OCONEE NUCLEAR STATION, UNIT NO. 1

AMENDMENT TO FACILITY OPERATING LICENSE

Amendment No. 51
License No. DPR-38

AMENDMENT NO. 51 TO DPR-38

Figure 3.1.2-1b
Amendment Nos. 51, 51 & 48

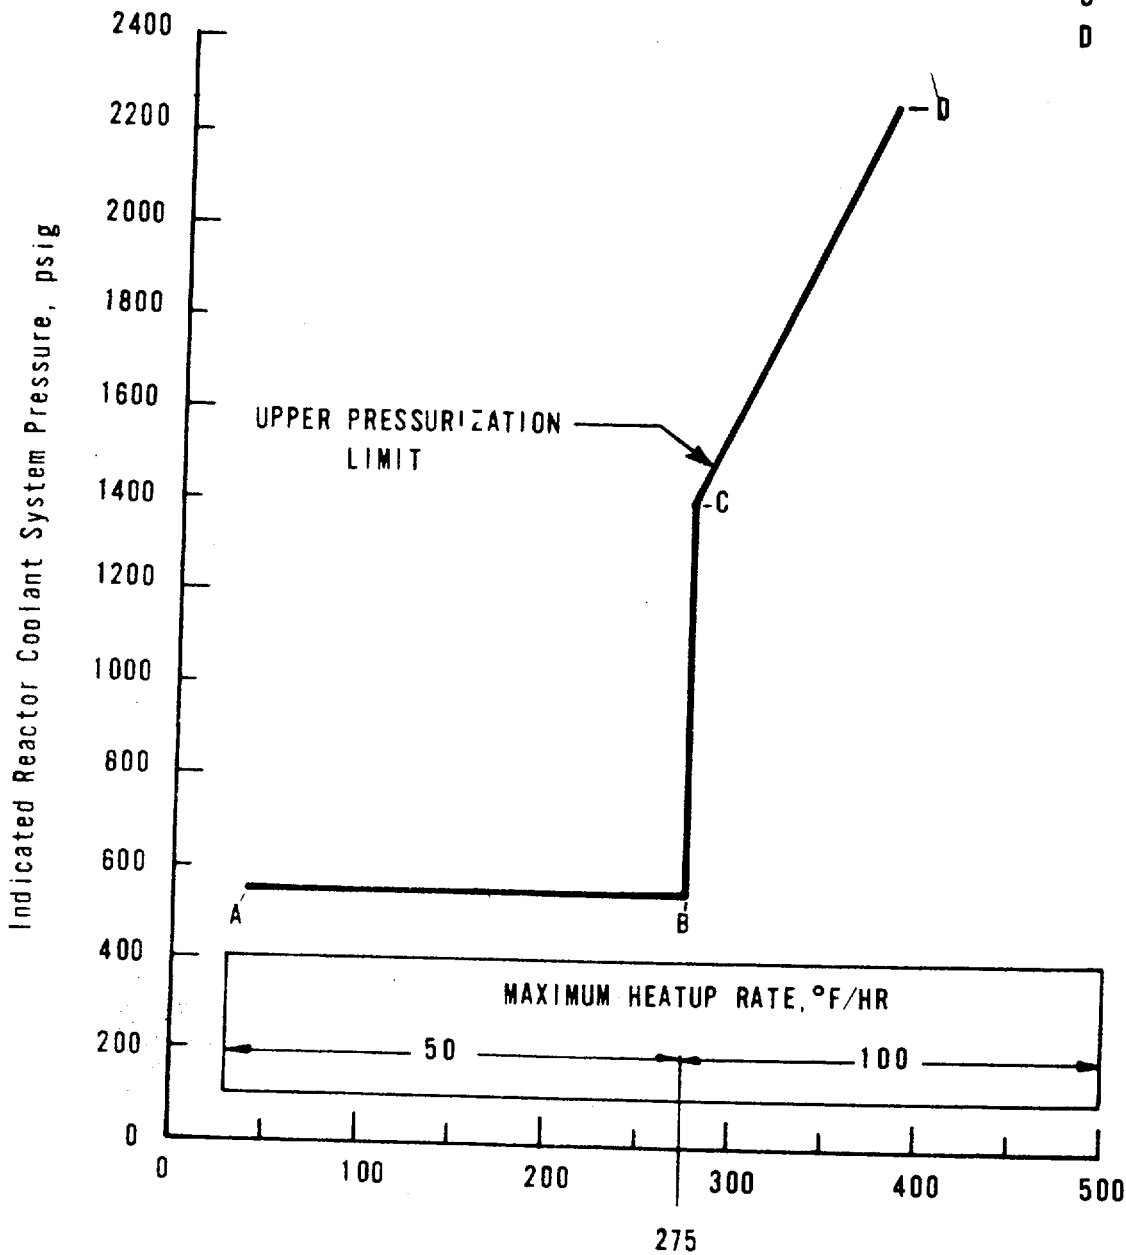
These amendments revise the common Oconee Technical Specifications to incorporate changes to the Oconee Unit 2 pressurization heatup and cooldown limitations.

The proposed revised Oconee Unit 2 pressure-temperature operating limit curves, Figures 3.1.2-1B, 3.1.2-2B and 3.1.2-3B are based on data from Babcock & Wilcox Report, "Analysis of Capsule OCII-C From Duke Power Company Oconee Nuclear Station, Unit 2, Reactor Vessel Materials Surveillance Program," BAW-1437, dated May 1977. The proposed curves are projected for 6 EFPY.

We have reviewed BAW-1437 and the proposed pressure-temperature operating limit curves. Capsule C from Unit 2 contained specimens of weld metal WF 209-1. This weld is not identical to the welds in Oconee Unit 2. However, this weld has a similar chemical composition and was made using weld procedure similar to those for high copper Oconee vessel welds. Therefore we conclude that the properties of the limiting weld metals in the Oconee reactor vessels will be affected by irradiation in a manner similar to these WF 209-1 specimens. Also, the Oconee Unit 2 and Unit 1 neutron flux, flux spectrum and weld material mechanical properties are similar. The Oconee Unit 1 pressure-temperature limits were approved on February 23, 1977, and were applicable for 4 EFPY. For the reasons stated in our Safety Evaluation Report issued February 23, 1977 on Oconee Unit 1, we have concluded that the proposed temperature operating limit curves for Unit 2 should also be limited to 4 EFPYs of operation.

Based on our review of the Oconee Unit 2 pressure-temperature limits and the similarity of the Oconee Unit 2 and Unit 1 designs, materials and operating conditions, we conclude that the operating limits proposed for Unit 2 are in conformance with Appendix G, 10 CFR Part 50, and are therefore acceptable.
